IN THE UNITED STATES PATENT AND TRADEMARK OFFICE

In re Application of)	
)	
PANUNTO, John P.)	
)	
Serial No: 10/660,533)	Art Unit: 3653
)	
Filed: 09/12/2003)	Examiner: MORRISON, Thomas A.
For: LARGE CAPACITY BOTTOM	M FEED D	DISPENSER
		March 21 2006
Mail Stan Nan Eag Amandmant		March 31, 2006
Mail Stop Non-Fee Amendment		
Commissioner for Patents		
P.O. Box 1450		
U.S. Patent and Trademark Office

RESPONSE TO OFFICE ACTION DATED 01/03/2006

Fig. 3

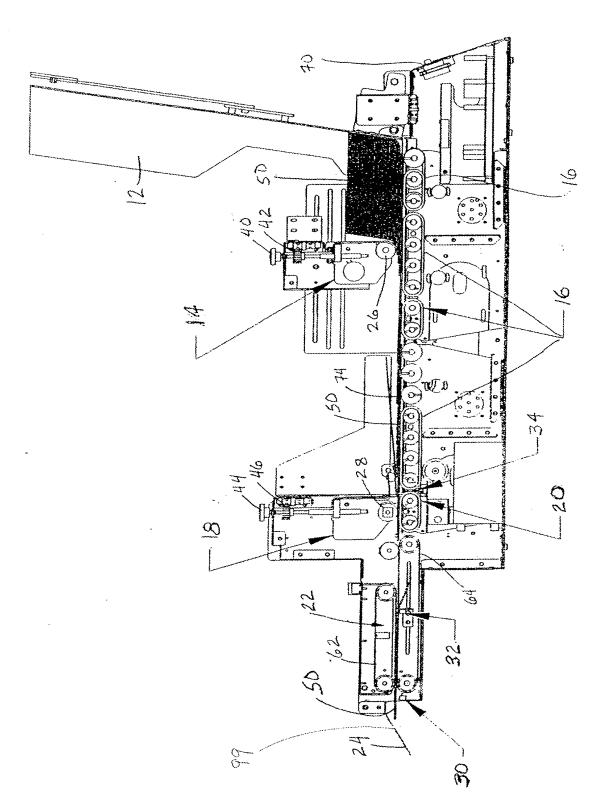
The drawings were objected to because of the reasons set forth in section 1 of the Office Action. In response, Figure 3 has been amended to remove reference character 22 pointing to the axle of the transport conveyor. Figure 3 has also been amended to label the location of the box ready sensor 99. In a related amendment, paragraph [0054] has been amended to identify the "box ready sensor" as --box ready sensor 99--. In view of these amendments, it is respectfully submitted that the drawings are now in proper form, and withdrawal of the objection to the drawings is requested.

The attached sheet of drawings includes changes to Figure 3. This sheet replaces original Figure 3.
